COMPASS

Building Review for 27 Pondfield, Rd – Ware Malcomb Response

Ware Malcomb – Response to Building Inspector Comments

Building Plan Comments – Bronxville, NY

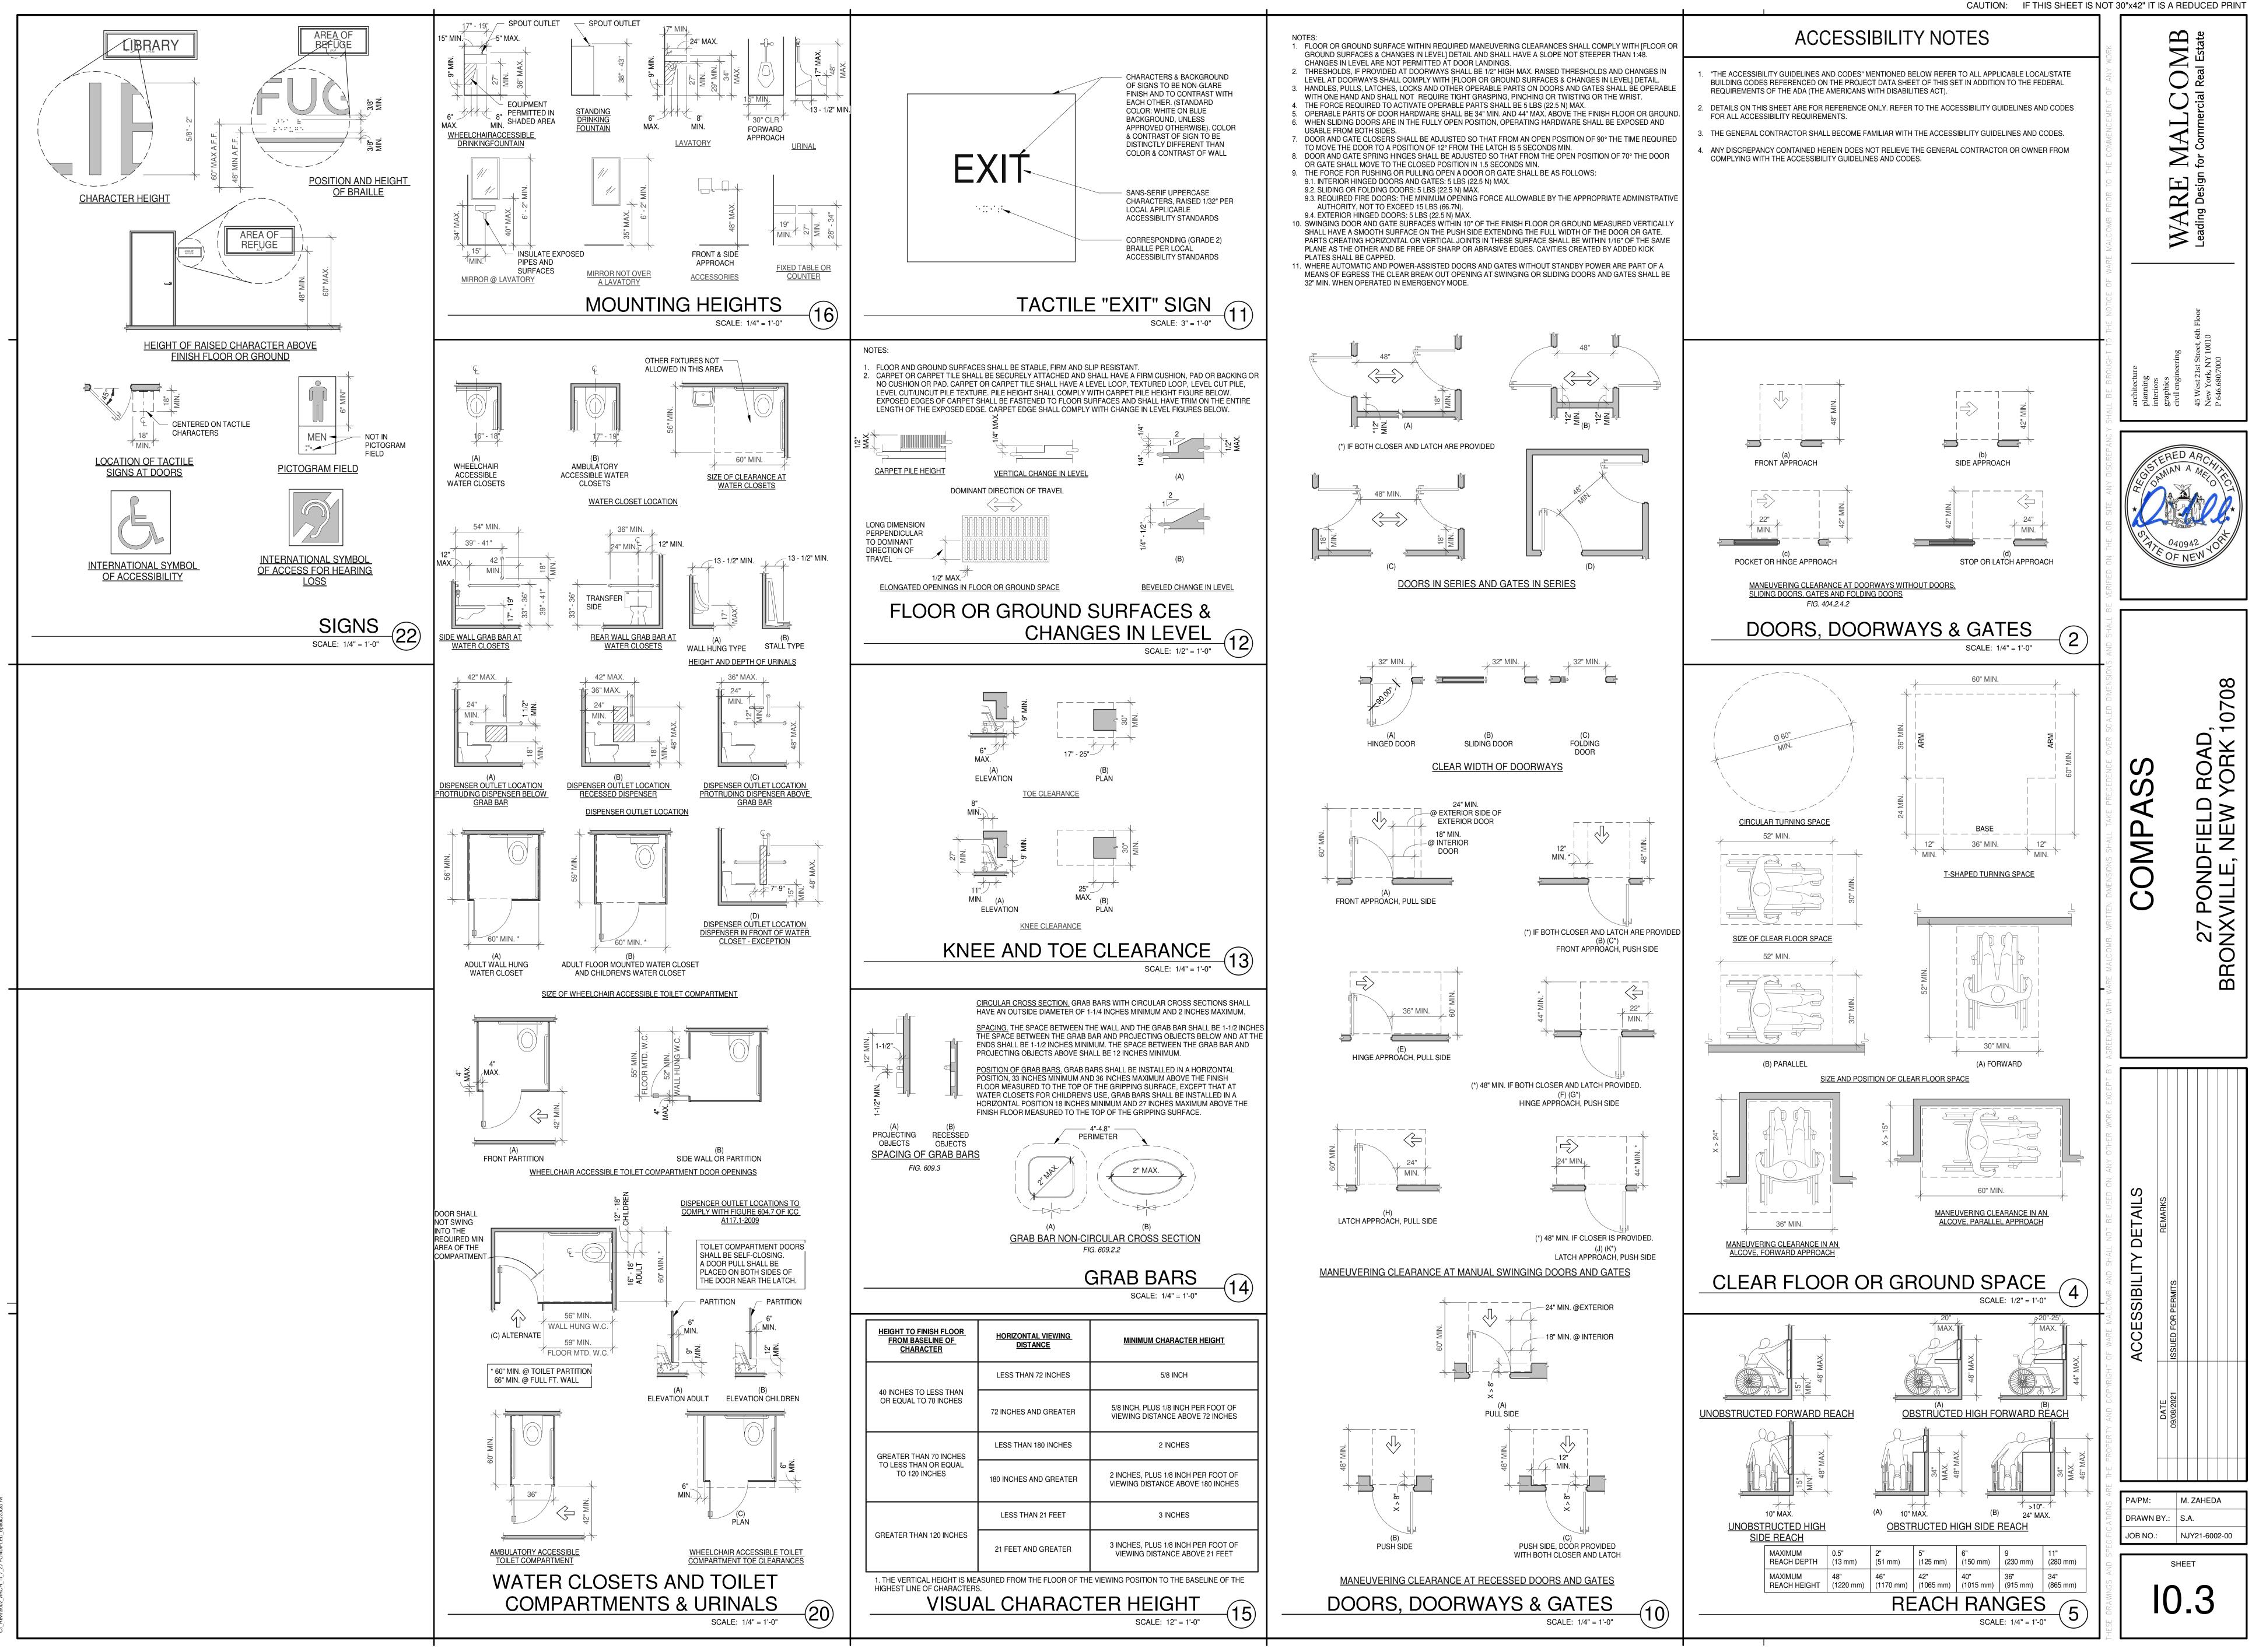
2) PAGE 10.5 OCCUPANCY AND EGRESS PLAN SHOWS OCCUPANT LOAD OF 50 SF PER PERSON. IT IS ASSUMED THAT THE IFC SECTION 1004.8 CONCENTRATED BUSINESS USE AREA IS BEING USED FOR THIS. THE CONCENTRATED USE AREAS FOR THIS SECTION SHOULD BE DETAILED, AND NOT TO INCLUDE THE BATHROOM.

<u>*WM*</u>: Yes, concentrated business use is being used for the occupancy and egress plan on I0.5 and does not include the conference room or the restroom or elec/IT closet.
